State of California – A Natural Resources Agency
OFFICE OF ENERGY INFRASTRUCTURE SAFETY
715 P Street, 15th Floor | Sacramento, CA 95814
916.902.6000 | www.energysafety.ca.gov

NOTICE OF NON-PERFORMANCE

Electrical Corporation:	Pacific Gas and Electric Company
Report Number:	PAD_PGE_IAG_20260708_1608
Inspector:	Ivan Garcia
WMP Year Inspected:	2025
Quarterly Data Report (QDR) Referenced:	Quarter 4 (Q4)
Inspection Selection:	Energy Safety viewed the contents of the Q4 QDR and performed an analysis that resulted in the selection of the WMP initiatives and locations referenced in this report.
Relevant WMP Initiative(s):	8.1.7.2 – Open Work Orders – Distribution Tags
Date of Inspection:	July 8, 2026
City and/or County of Inspection:	Santa Maria, Santa Barbara County
Inspection Purpose:	Assess the accuracy of Pacific Gas and Electric Company's QDR data, completeness of its work, and performance of WMP requirements.

Deficiency 1

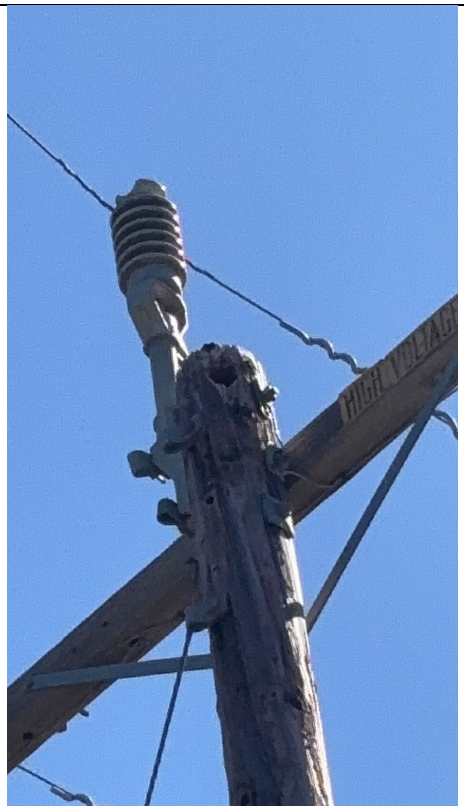
On Structure ID 121143479, Grid Hardening ID 123957744 at 9000-9152 Alisos Canyon Rd, Santa Maria, CA, 93455, USA, 34.7471215847129, -120.194272588932, the inspector observed a woodpecker (WP) hole greater than one (1) inch in diameter and within two (2) inches of attachment hardware at this location. The inspector's observation is documented in Deficiency 1 photographs, which are attachments to this report. Photo numbers Asset Image 1 and Asset Image 2 depict a woodpecker hole present near the top of the pole and Item1IB1Img1-1, Item1IB1Img1-2, and Item1IB1Img1-3 are references used to evaluate the pole condition. In the 2025 Q4 Quarterly Data Report submission, PG&E reported that work on WMP initiative 8.1.7.2 – Open Work Orders – Distribution Tags was completed at this location.

1. Distribution tag that had been created for the inspection location was cancelled and found not be "non-compelling per updated TD-2305M-JA02, Rev. 14" according to PG&E's distribution tag long text.
2. Inspector observed a woodpecker hole greater than one (1) inch in diameter and within two (2) inches of attachment hardware at this location.
3. Woodpecker holes greater than one (1) inch in diameter and within two (2) inches of attachment hardware warrants pole reframe or replacement per PG&E document TD-2305M-JA02, Rev. 14.

Asset Image 1: WP hole.

Deficiency 1. Energy Safety observed that in implementing 2025 WMP initiative 8.1.7.2 – Open Work Orders – Distribution Tags, PG&E failed to complete work on an open work order – distribution tag on Structure ID 121143479, Grid Hardening ID 123957744 at coordinates 34.7471215847129, -120.194272588932. Energy Safety considers this non-performance to be in the Minor risk category. PG&E must complete a corrective action for this deficiency by 12 months of this notice.[1]
